Subject: TRANSMITTAL OF REVISED VERSION OF DESCRIPTION OF THE TOTAL SYSTEM  
PERFORMANCE ASSESSMENT AND INTEGRATION ISSUE RESOLUTION  
BLUEPRINT—IM 20.01402.761.140

**DESCRIPTION OF THE TOTAL SYSTEM  
PERFORMANCE ASSESSMENT  
AND INTEGRATION ISSUE  
RESOLUTION BLUEPRINT**

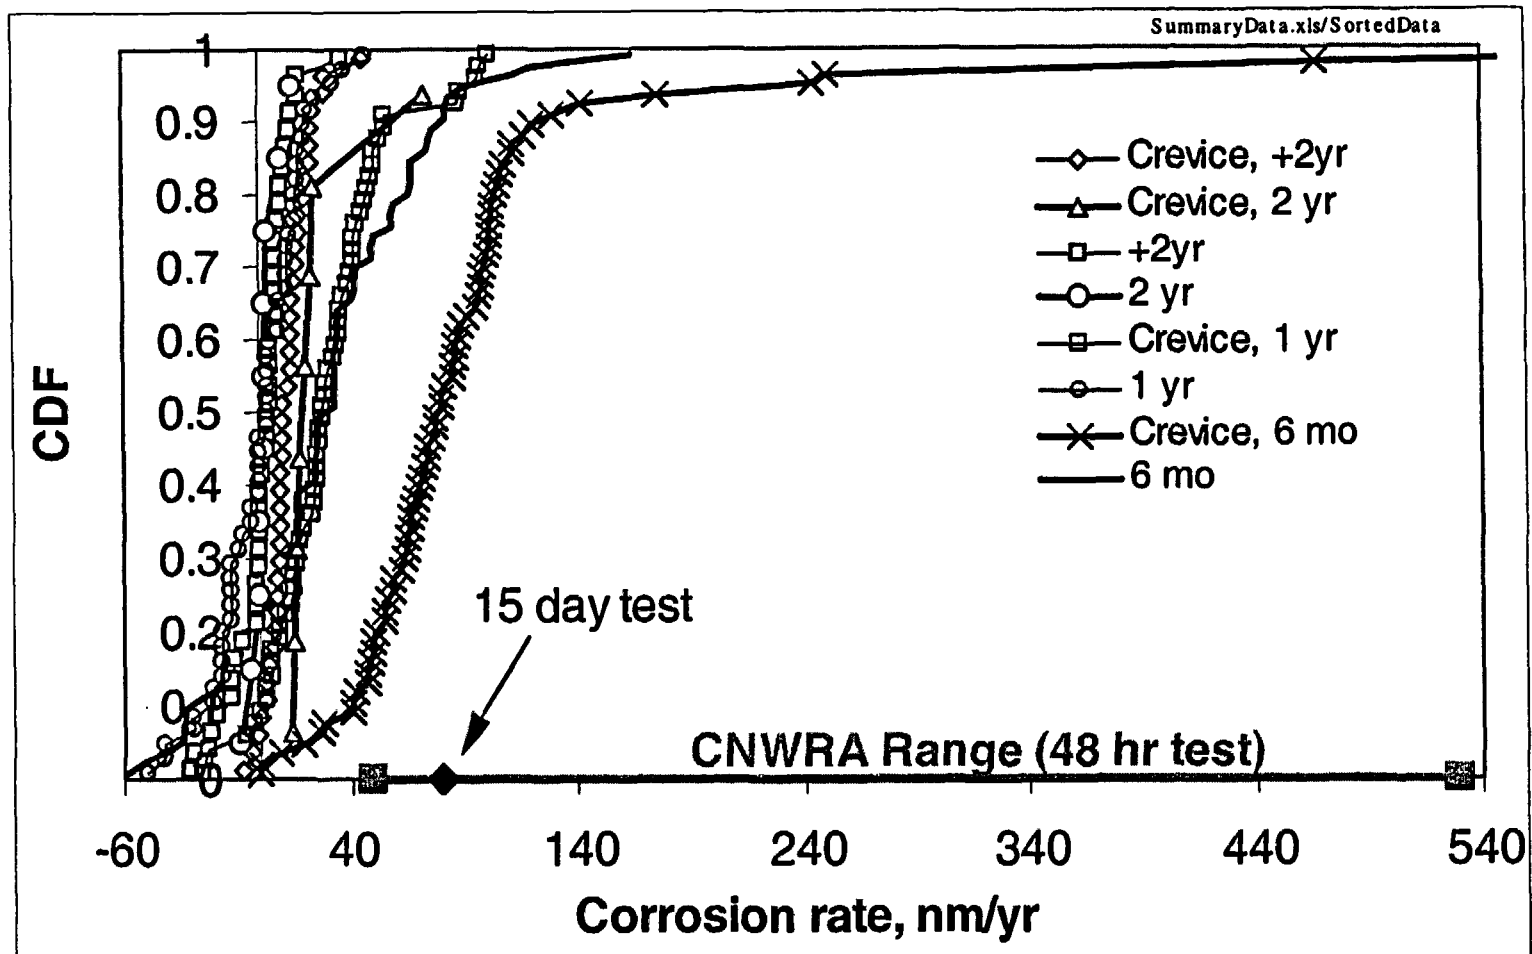
Crevice samples yield higher corrosion rates, why?

- Equation to compute corrosion rates (Equation 3-15 in WP Deg PMR, 2000):  $r = w/(A \rho t)$ 
  - $w$ , measured weight loss;  $A$ , reference surface area (30.65 and 57.08 cm<sup>2</sup> for weight loss and crevice samples, respectively);  $\rho$ , alloy density;  $t$ , time of test.
- Is it possible that enhanced corrosion rates as a result of a less protective film are occurring in the crevice area? Is the equation adequate to compute corrosion rates if there are localized regions of enhanced dissolution?

Figure 3.4-19. Degradation Profiles for Time to First Failure: Drip Shield Patch, Waste Package Crack, Waste Package Patch

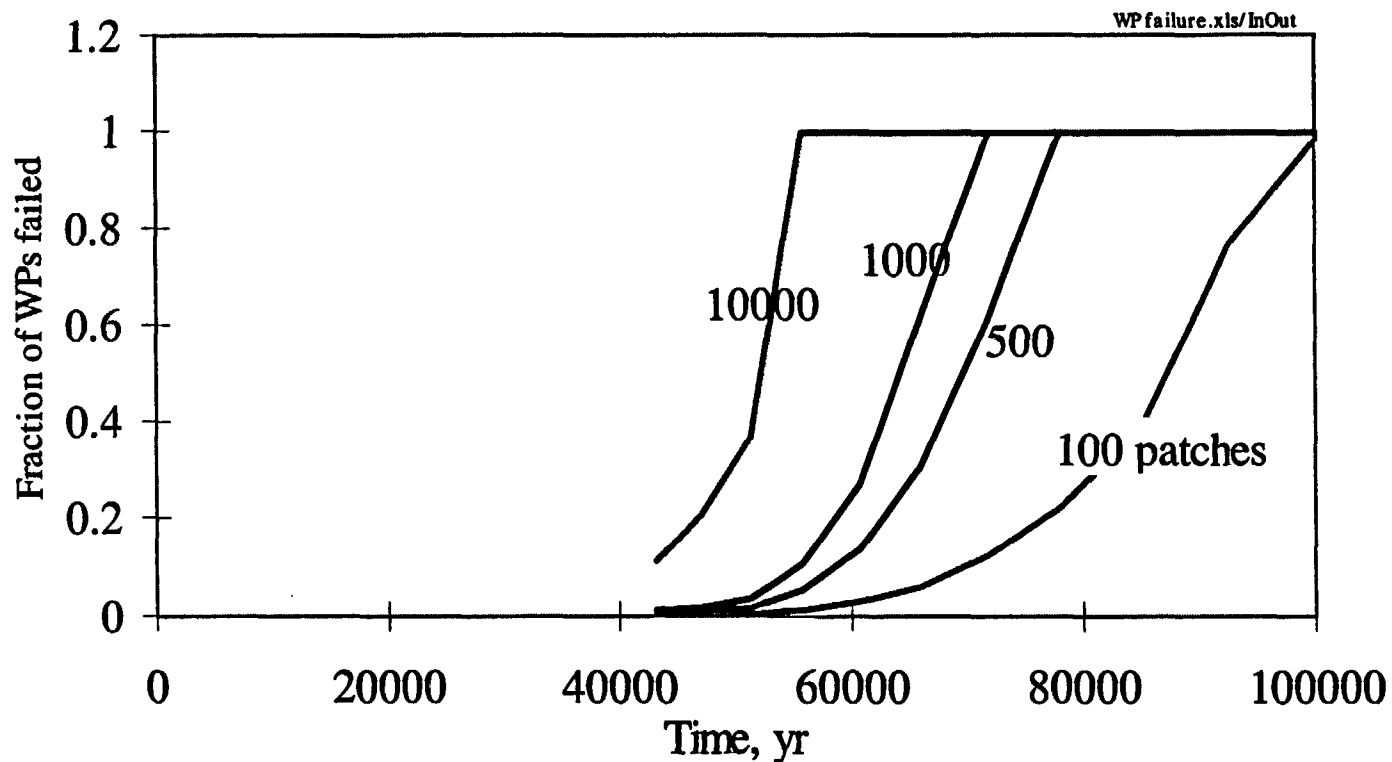
Curves in this figure (from TSPA-SR, TDR-WIS-PA-000001 Rev 00 ICN 01), are not well-defined.

The fraction of WPs failed (1st patch penetration) is an ill-defined quantity. It depends on the number of assumed patches on the WP surface.
